## Proposed amendment to GCU Appendix 9

<b>Title</b>	New element: Code 3.2.4.5_ 3.2.4.6 radial fins/circular cooling bars Nowy element: Kod 3.2.4.5_ 3.2.4.6 żebra promieniowe / chłodzenie kołowe, słupy	
<b>Proposed amendment made by: RU / keeper / other body:</b>	DB Cargo	
<b>Proposed amendment concerns:</b>	<input checked="" type="checkbox"/> Appendix 9	<input type="checkbox"/> Appendix 11
<b>Proposer:</b>	Sven Seligmann	
<b>Location, date:</b>	Mainz, 02/09/2019	
<b>Concise description:</b>	New element: Code 3.2.4.5_ 3.2.4.6 broken radial fins/circular cooling bars on brake discs mounted on the axle Nowy element: kod 3.2.4.5_ 3.2.4.6 złamane żebra promieniowe / okrągłe pręty chłodzące na tarczach hamulcowych zamontowanych na osi

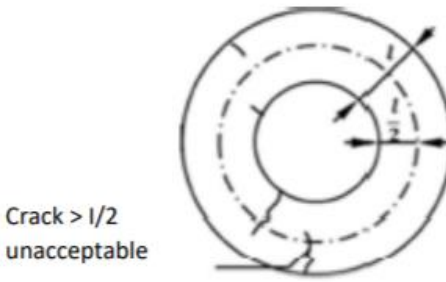
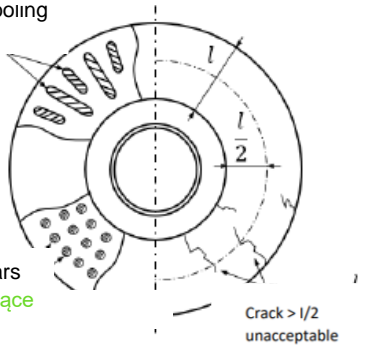
<b>2.1. Elimination of anomaly/problem (goal)</b>
Introduction of two new codes and a drawing in GCU Appendix 9, Annex 1. Code 3.2.4.5 Cooling <i>bars</i> and code 3.2.4.6 cooling fins.

cooling bars pręty chłodzące		
	3.2.4.4	pęknięcia w przekroju poprzecznym Crack in cross-section	Detach wagon	5
	3.2.4.5	Missing or cracked circular cooling bars - more than 2 side by side więcej niż dwa obok siebie - more than 6 in total	K + R1	3
	3.2.4.6	Cracked cooling fins - more than 4, with less than 3 cooling lines intact between the cracked fins więcej niż 4, z mniej niż 3 liniami chłodzenia nienaruszonymi między pękniętymi żebrawami	K + R1	3
